SUBJECT: Request for Exemptions from Development Regulations
Pursuant to Chapter 201H-38, Hawaii Revised Statutes (HRS)
Project: Fort Street Mall Affordable Senior Rental Housing
Landowner: Roman Catholic Church in the State of Hawaii
Applicant: Catholic Charities Housing Development Corporation
Agent: R.M. Towill Corporation (Isaiah Sato)
Location: 1155 and 1159 Fort Street Mall – Honolulu
Tax Map Keys: 2-1-010: 033 and 034

DEPARTMENT OF PLANNING AND PERMITTING
OF THE CITY AND COUNTY OF HONOLULU

PROJECT:	Fort Street Mall Affordable Senior Rental Housing
LANDOWNER:	Roman Catholic Church in the State of Hawaii
APPLICANT:	Catholic Charities Housing Development Corporation
AGENT:	R.M. Towill Corporation (Isaiah Sato)
LOCATION:	1155 and 1159 Fort Street Mall - Honolulu (Exhibit A)
TAX MAP KEYS:	2-1-010: 033 and 034 (Lots 2, 3, and 4)
LAND AREA:	6,900 square (sq.) feet (ft.)
STATE LAND USE:	Urban District
DEVELOPMENT PLAN AREA:	Primary Urban Center
ZONING:	BMX-4 Central Business Mixed Use District (BMX-4 District)
EXISTING USE:	Vacant two-story commercial/office building
SURROUNDING LAND USE:	Office buildings, meeting facility, personal services, eating and drinking establishments, un

Exhibit C-10

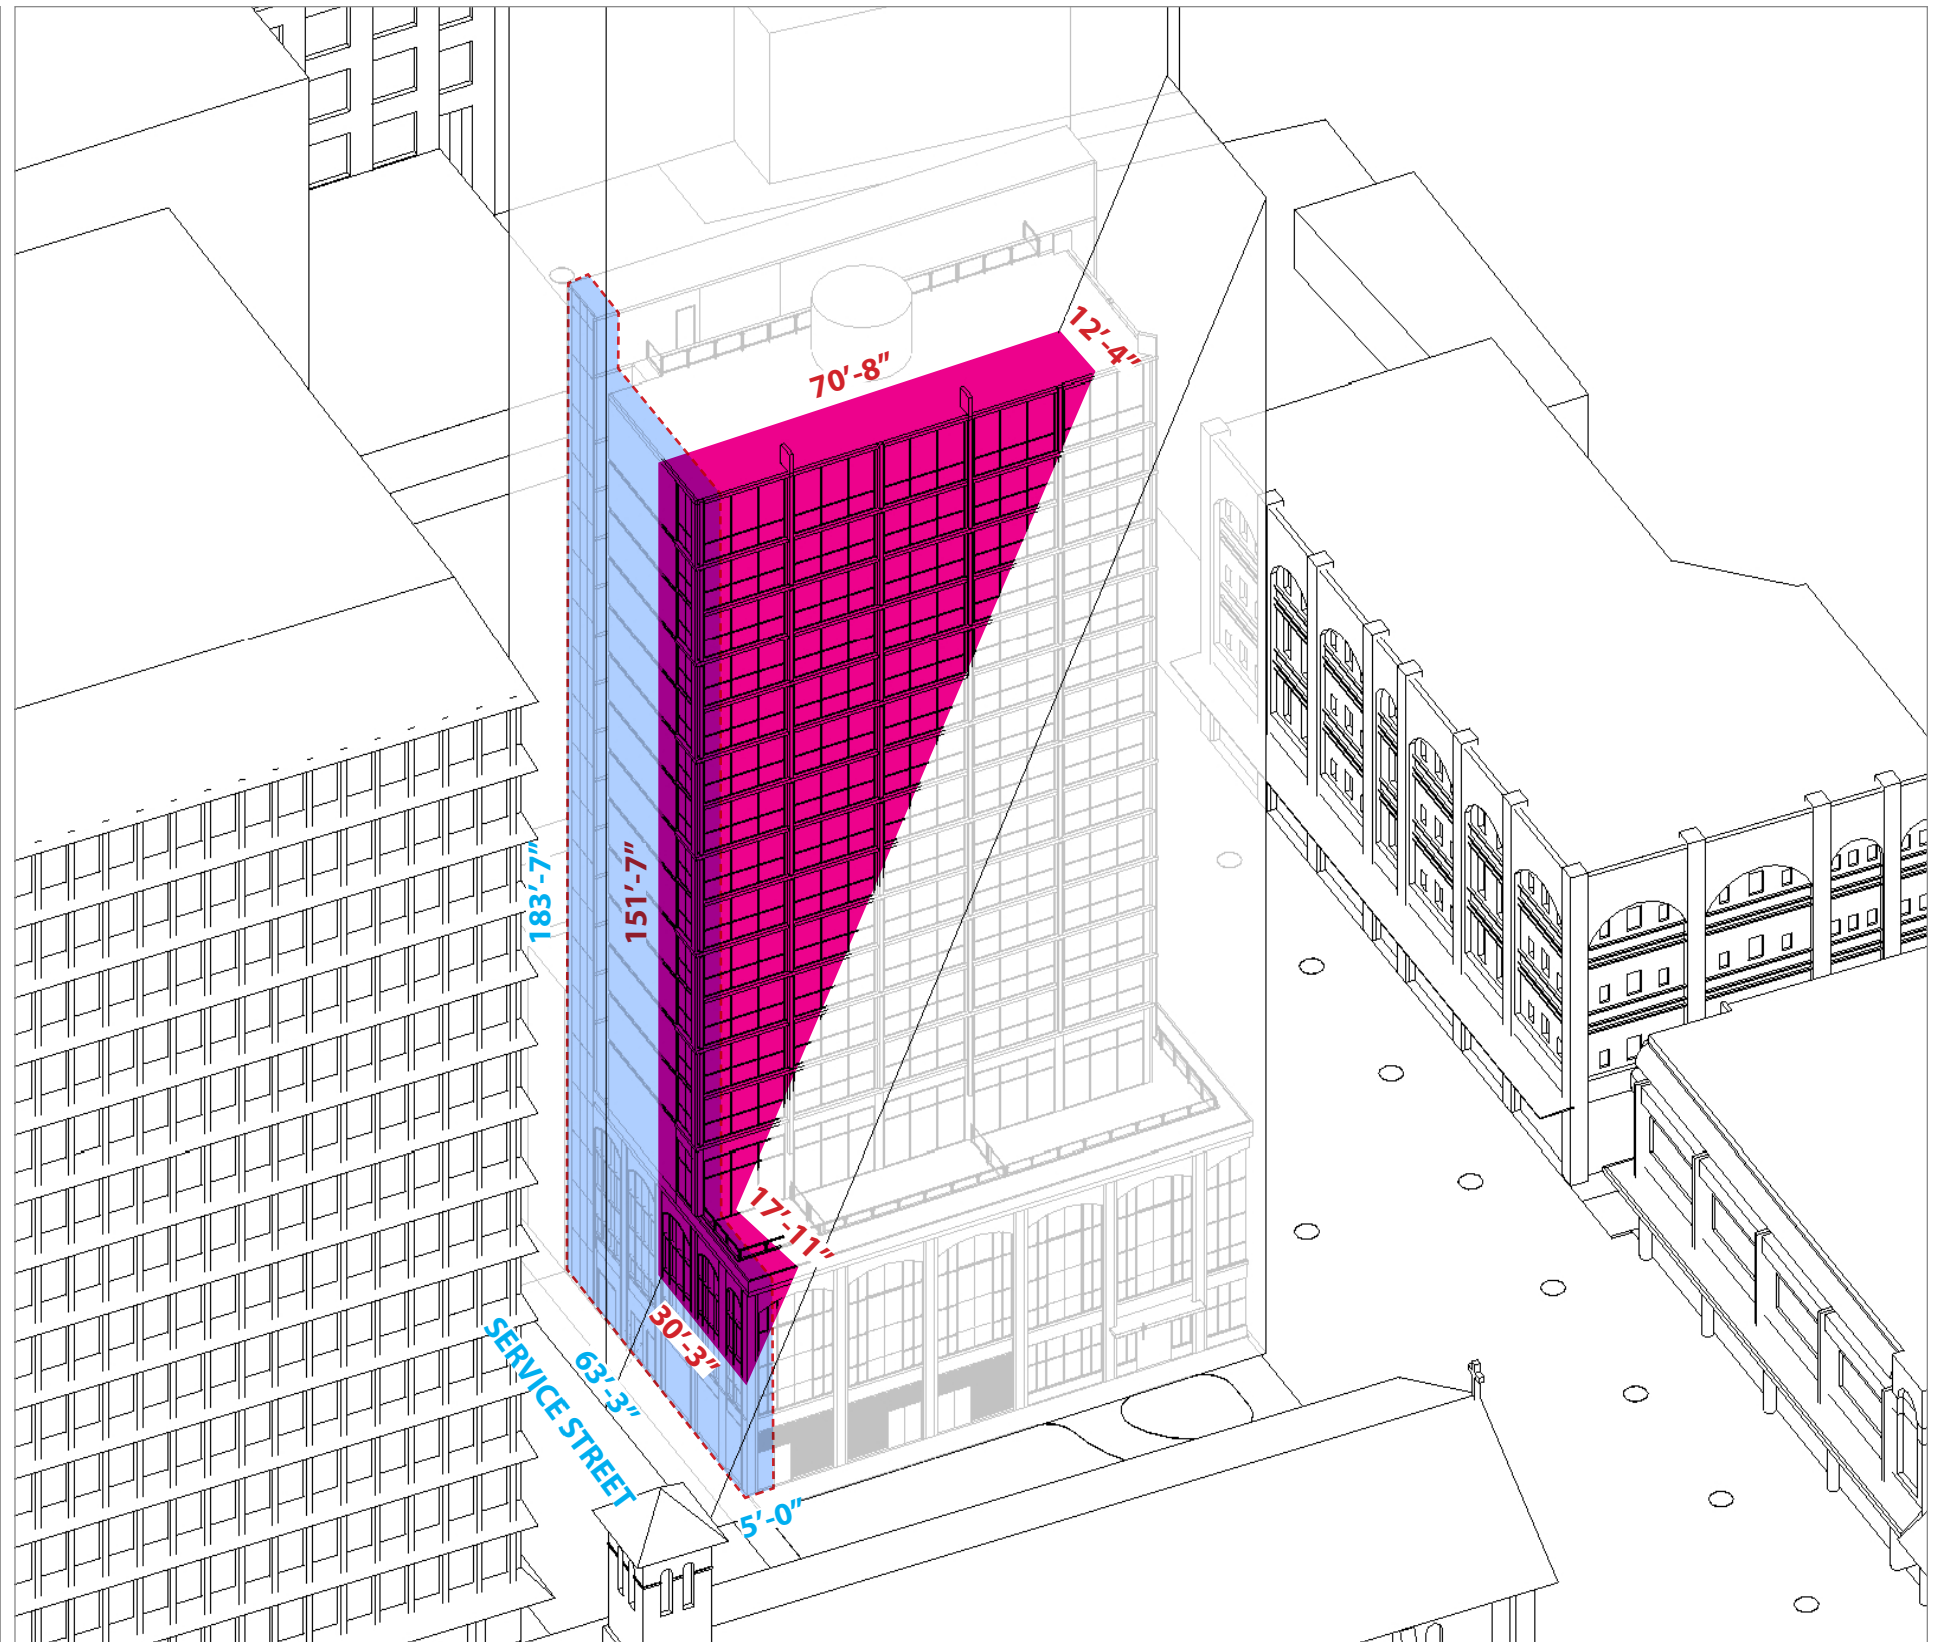
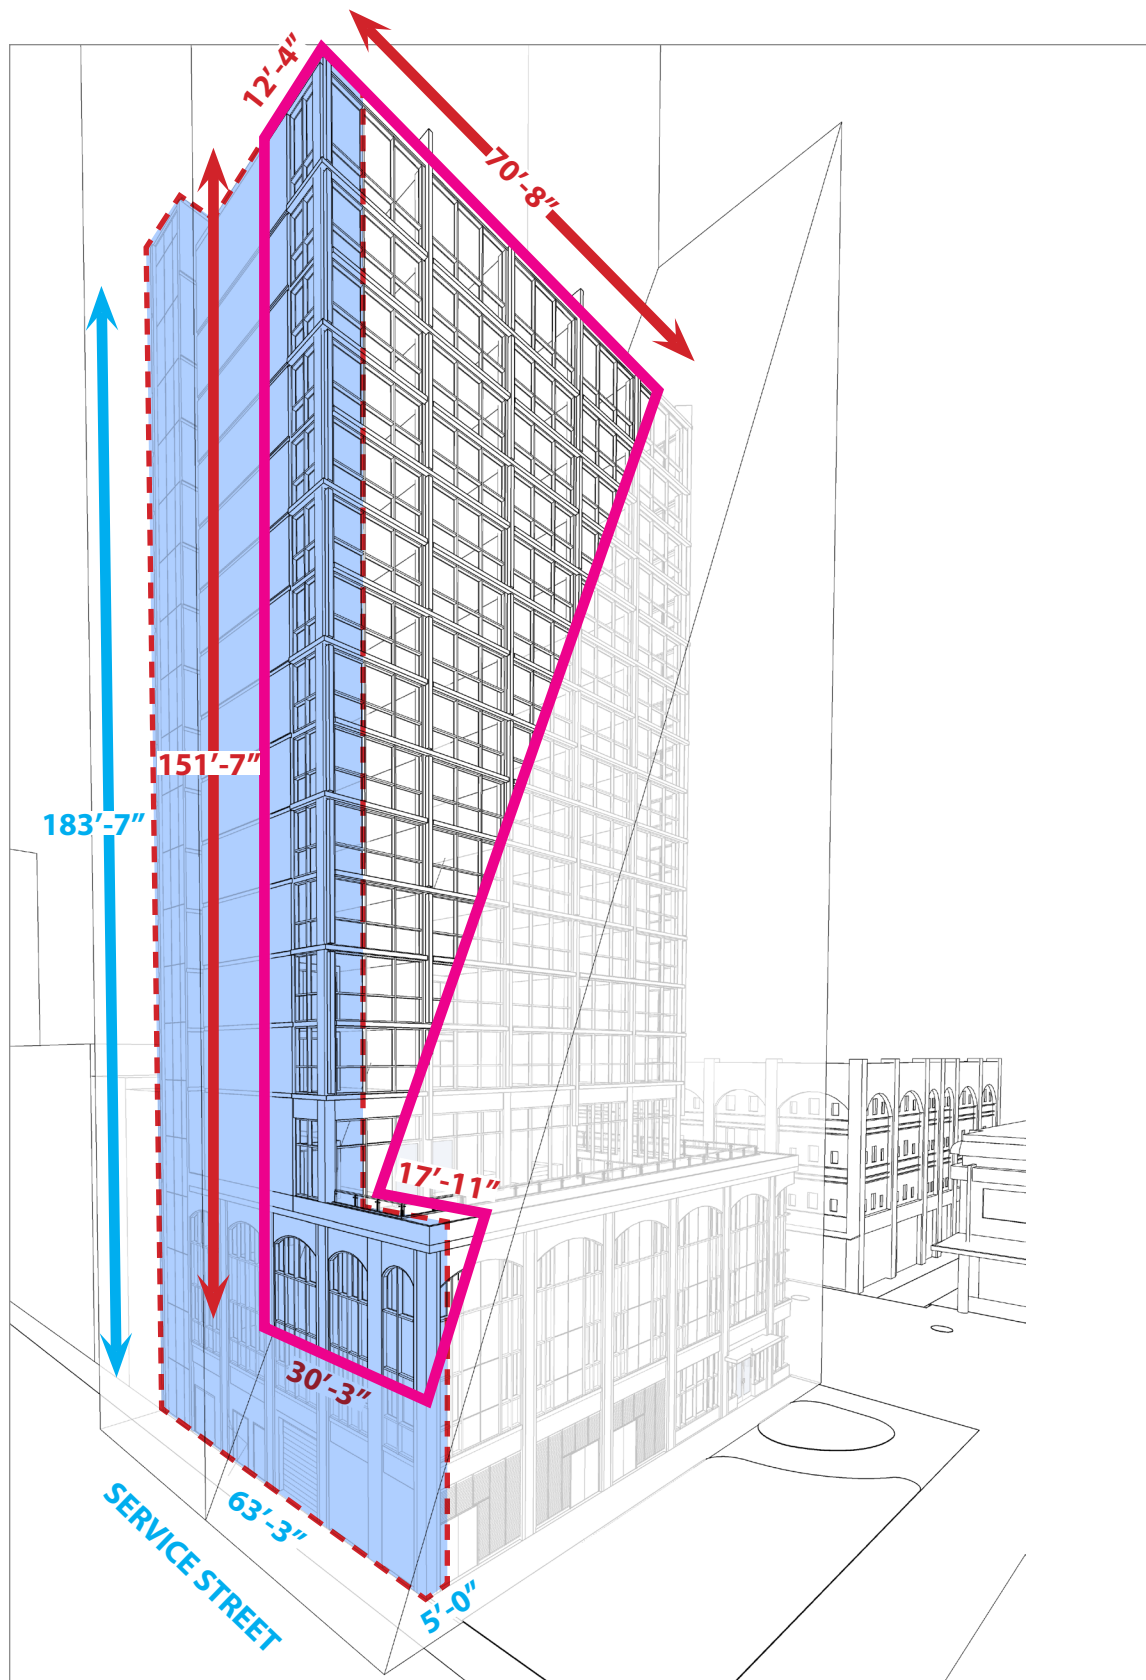
The proposed building will encroach vertically into the height setback by approximately 155 ft. and horizontally by approximately 75 ft. (see Exhibits C-10 and C-11). The encroachment into the height setback allows the Applicant to provide more affordable rental units. However, even though the Applicant is providing a significant community benefit with the affordable units, the encroachments into the setback increase the scale of the building, especially from the pedestrian view point. Therefore, as previously mentioned, the Applicant should utilize color schemes and patterns or use varying materials to create visual articulation to mitigate the scale and massing of the building. This should be a condition of approval.

Existing buildings adjacent to the site also encroach into the BMX-4 District height setback. Therefore, the encroachment is not out of the character with the surrounding area. Given these considerations and provided the Applicant mitigates the visual scale of the building, the DPP does not object to the encroachment into the height setback.
